Date: August 9, 2007  
To: T10 Technical Committee  
From: Alvin Cox ([alvin.cox@seagate.com](mailto:alvin.cox@seagate.com))  
Subject: SAS-2 6Gbps PHY Electrical Specification

Abstract: The attached information defines the electrical requirements for 6 Gbps transmitter devices and receiver device. In addition, updates include reference transmitter and receiver device definitions to provide a means of determining if a channel is compliant and a cable specification section with requirements for 6Gbps usage. This proposal is a continuation of 07-063, at it ran out of revisions available.

**Figure 118 Transmitter device common mode voltage limit**

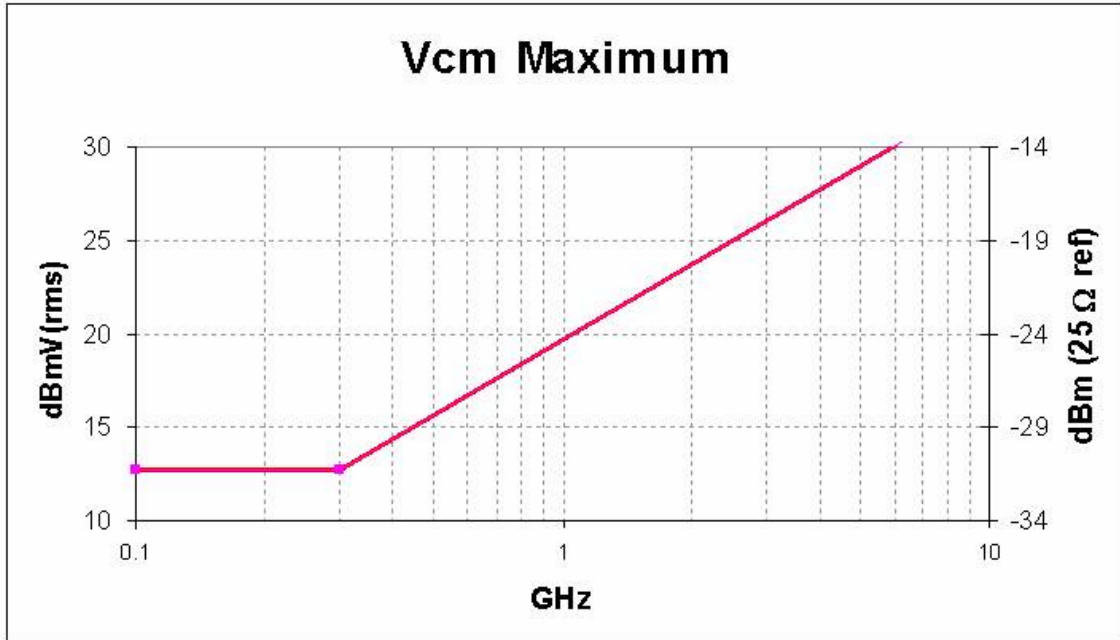
d Maximum value at the Nyquist frequency (3 GHz). See Figure 118.

Figure 119 Return loss variables

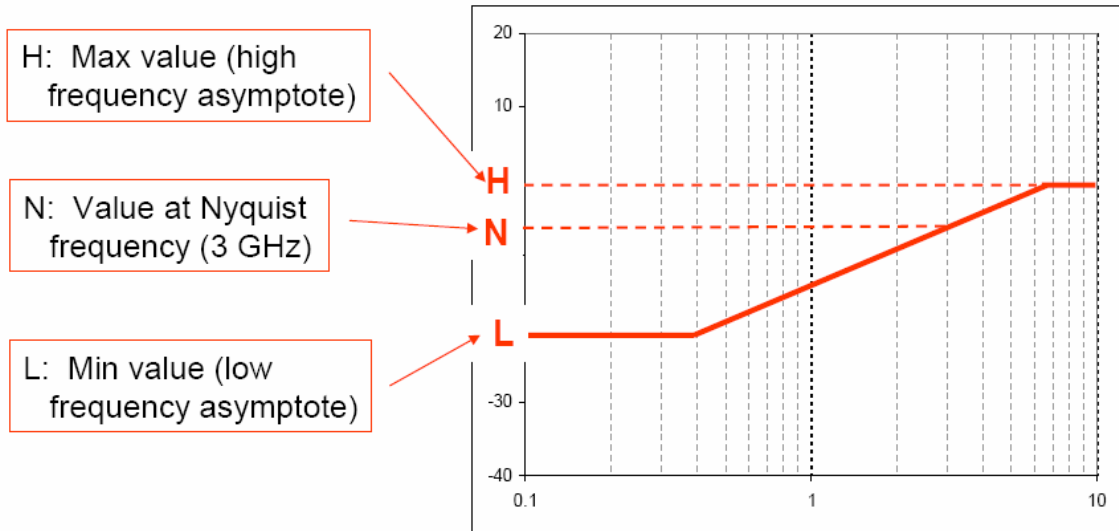
Return loss limits shall be calculated per the following formula. Variables are illustrated in Figure 119 and specified in Table 63.

$$\text{Measured Value} < \max [ L, \min [ H, N + 13.3 \log_{10}(F/3\text{GHz}) ] ]$$

Figure 120 Transmitter Differential and Common Mode Return Loss

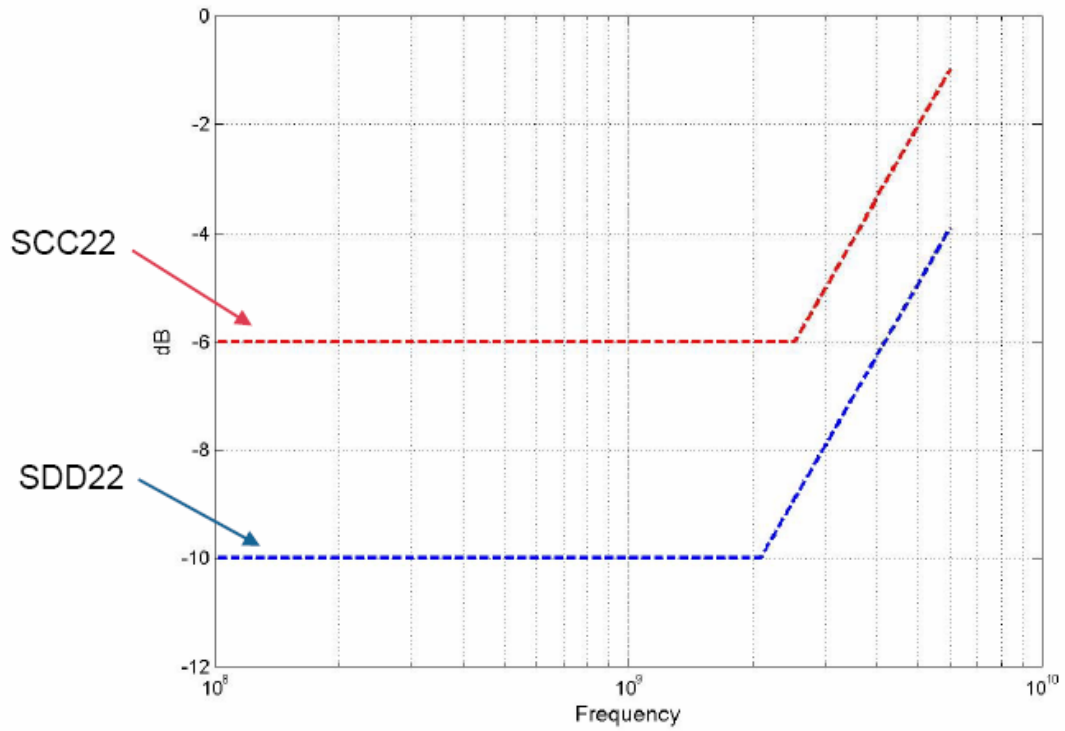
Characteristic	Figure	L(dB)	N(dB)	H(dB)	S(dB)	F <sub>Min</sub> (MHz)	F <sub>Max</sub> (GHz)
SCC22 common mode return loss	120	-6.0	-5.0	0	13.3	100	6.0
SDD22 differential return loss	120	-10	-7.9	0	13.3	100	6.0
SCD22 differential to common mode conversion	121	-26	-12.7	-10	13.3	100	6.0

**Figure 122 Transmitter equalization measurement**

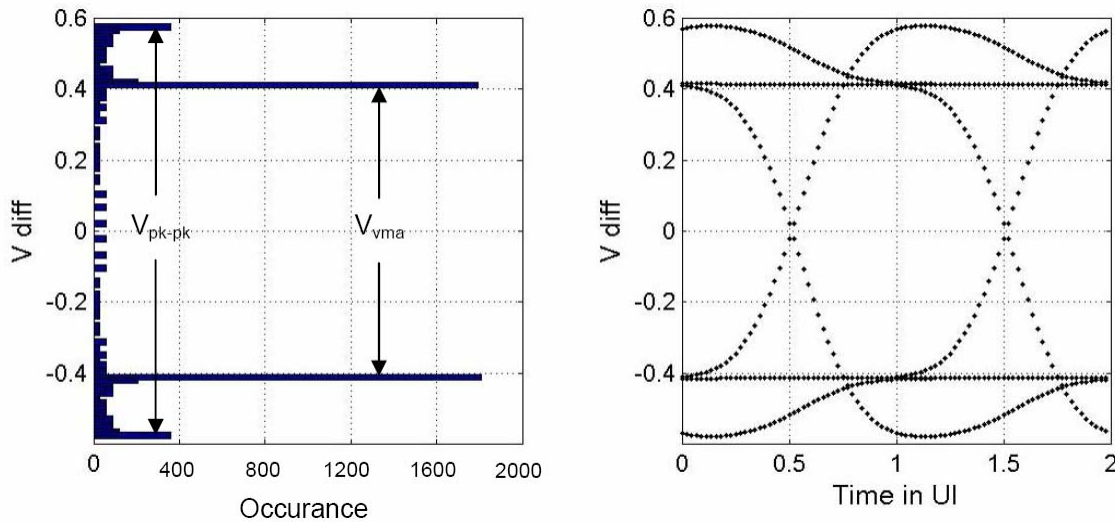
- c. The  $V_{vma}$  mode value and  $V_{pk-pk}$  peak value shall be determined as illustrated in Figure 122. A sample size of 1000 minimum, 2000 maximum histogram hits for  $V_{vma}$  shall be used to determine the values. The histogram in the figure is a combination of two histograms, an upper histogram for TX+ and lower histogram for TX-. (The histograms on the left of the test pattern signal displayed on the right.) The  $V_{vma}$  mode value and  $V_{pk-pk}$  peak value are determined by adding the values measured for TX+ and TX-.

$$DE_{dB} = 20 \text{Log}_{10} \left( \frac{V_{pk-pk}}{V_{vma}} \right)$$

**Figure 123 Receiver Differential and Common Mode Return Loss**

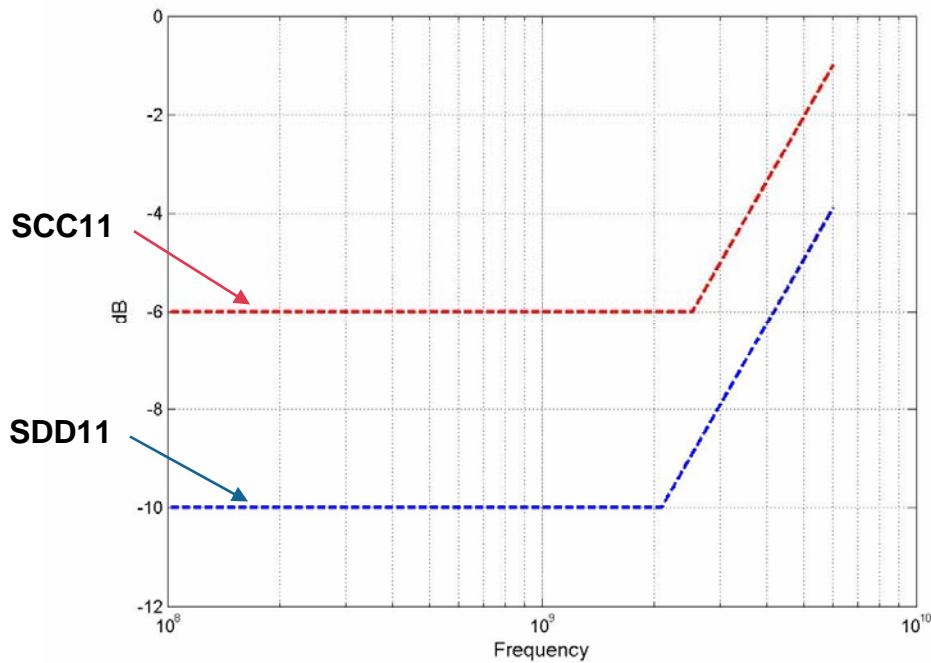
Characteristic	Figure	L(dB)	N(dB)	H(dB)	S(dB)	F <sub>Min</sub> (MHz)	F <sub>Max</sub> (GHz)
SCC11 common mode return loss	123	-6.0	-5,0	0	13.3	100	6.0
SDD11 differential return loss	123	-10	-7,9	0	13.3	100	6.0
SCD11 differential to common mode conversion	124	-26	-12,7	-10	13.3	100	6.0
